ADDENDUM

21st Century Cyber Charter School

Building Renovations: 1245 Wrights Lane

M/M Architects Project: 18-21stC-02

GENERAL NOTES & TYPICAL DETAILS

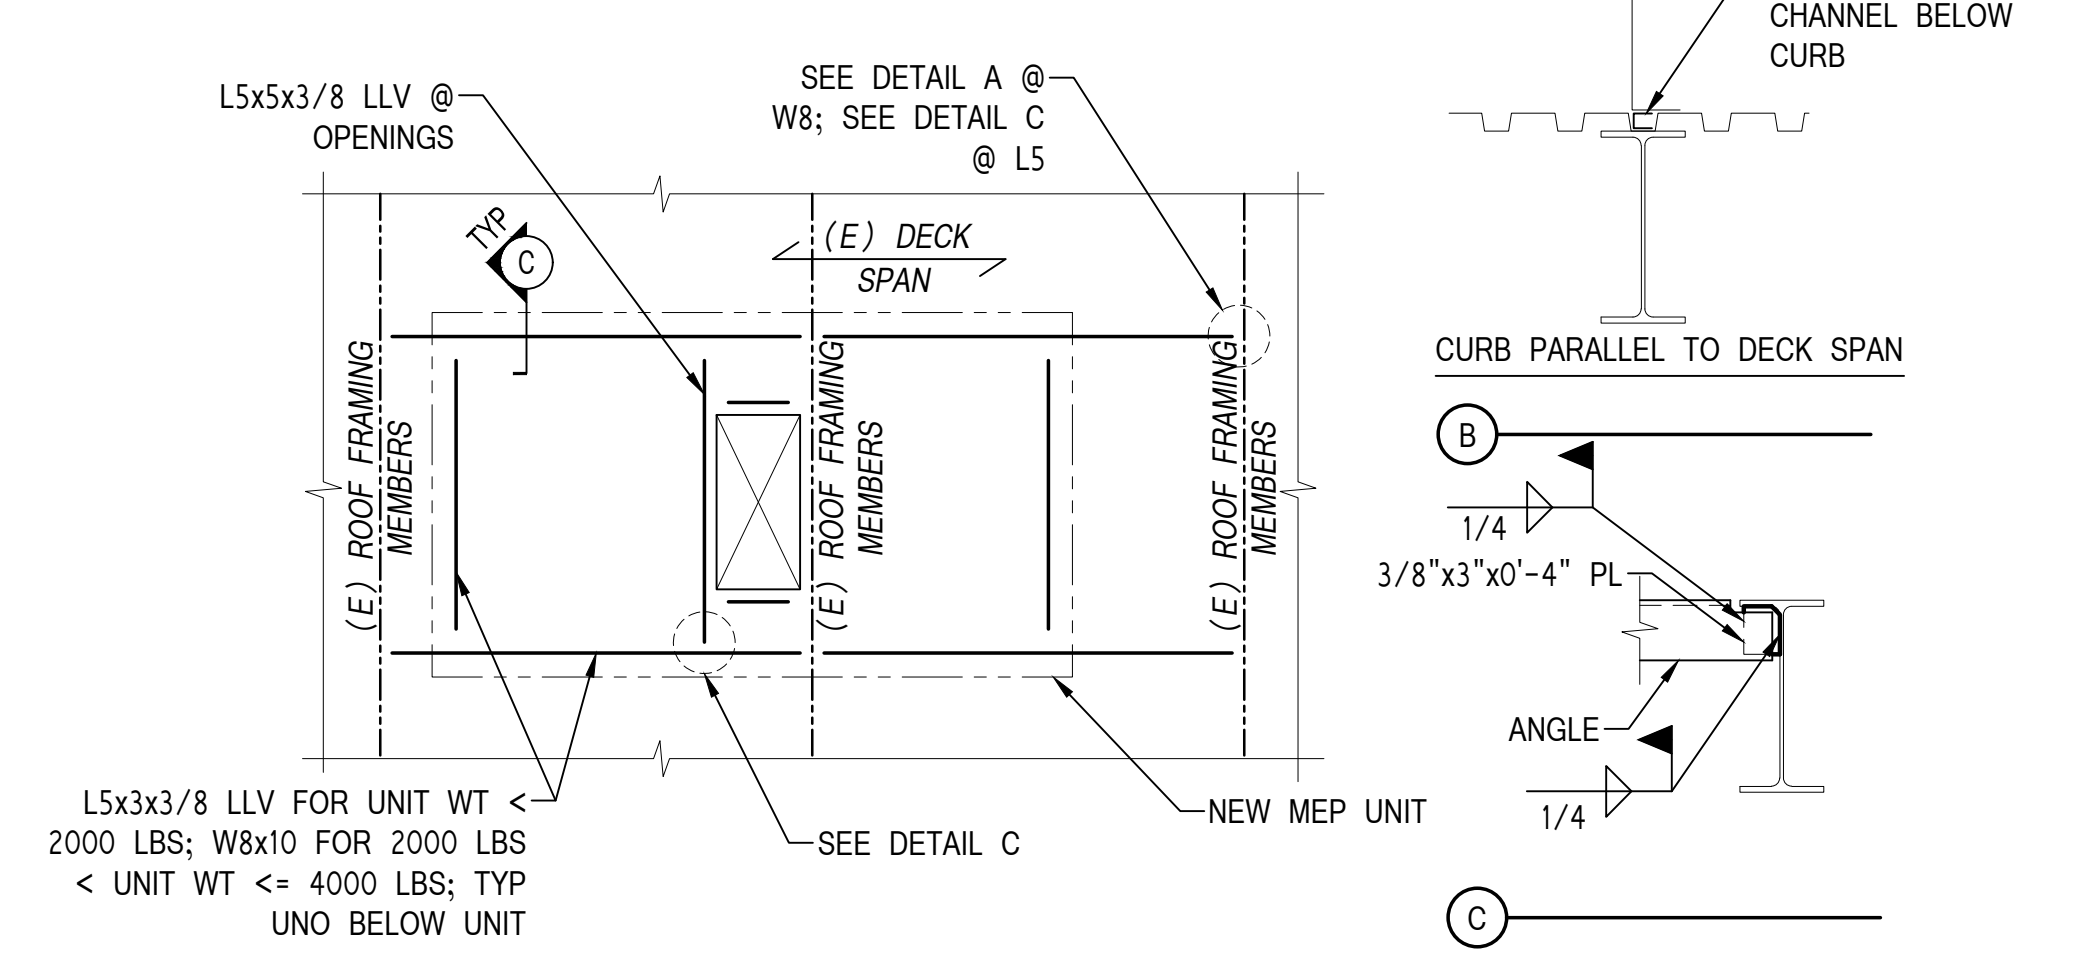
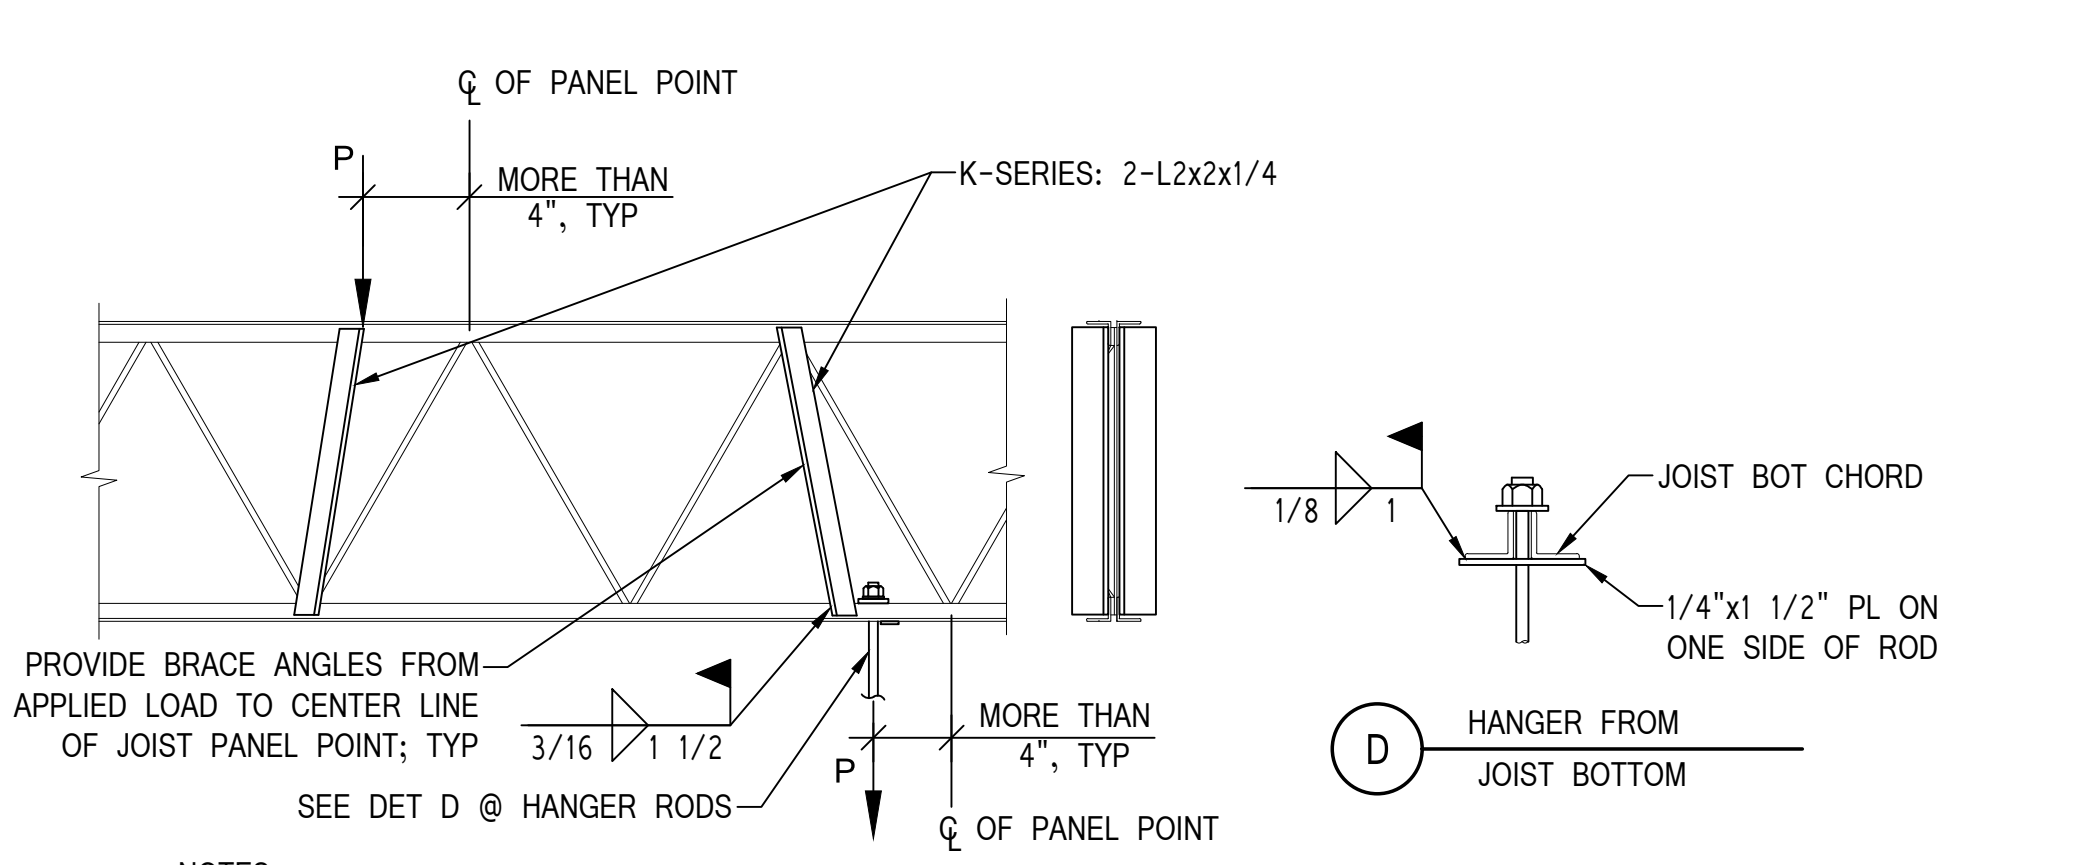
04.08 Refer to attached new Sheet S1.0 GENERAL NOTES & TYPICAL DETAILS. The information on the sheet falls under the responsibility of the GC and shall be coordinated with the mechanical unit work by the MC.
